Construction Information Memorandum No. 4 - 2019

TO: Region Engineers
ATTN: Area Operations, Construction, and Local Transportation Engineers
FROM: Winston J. Powe, P.E. 
State Construction Engineer
RE: Guardrail Height Adjustment

Special Provision No. 18-0404

SUBJECT: Guardrail Reset.

GUARDRAIL HEIGHT ADJUSTMENT

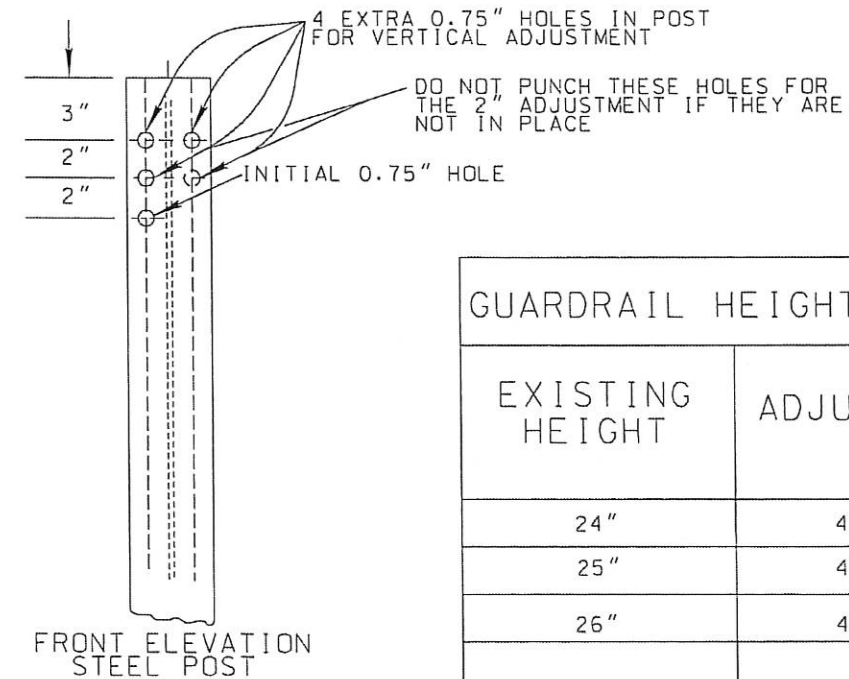
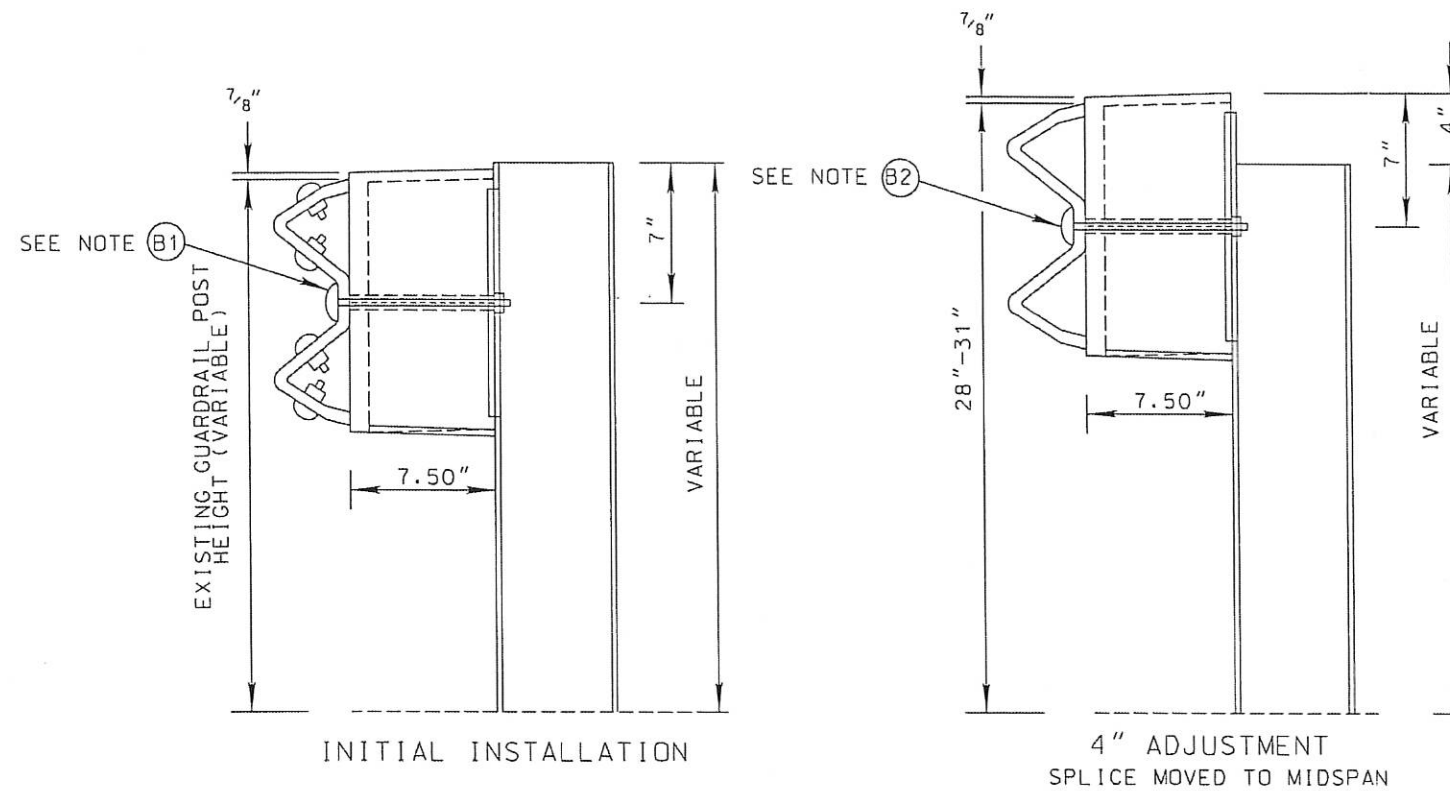
The attached June 15, 2018 memorandum from the Design Bureau addresses the resetting of existing guardrail in order to meet MASH height requirements. The memo, along with Special Project Detail Index No. 325, describes only the punching of new holes in rail sections and in posts to facilitate height adjustment.

Please be aware that Subarticle 631.02(a) of SP 18-0404 also allows drilling of these holes. Regardless of the method used by the contractor to produce new holes, it should be noted that a galvanizing repair paint may be necessary if any damage occurs to any of the guardrail members during this operation.

Attached is a Special Project Detail that shows adjustments to existing guardrail. The adjustments include raising the height, moving the splice to midspan and providing crashworthy blockouts.

The Design Bureau will be adding a note to the Special Project Detail to address the drilling of holes.
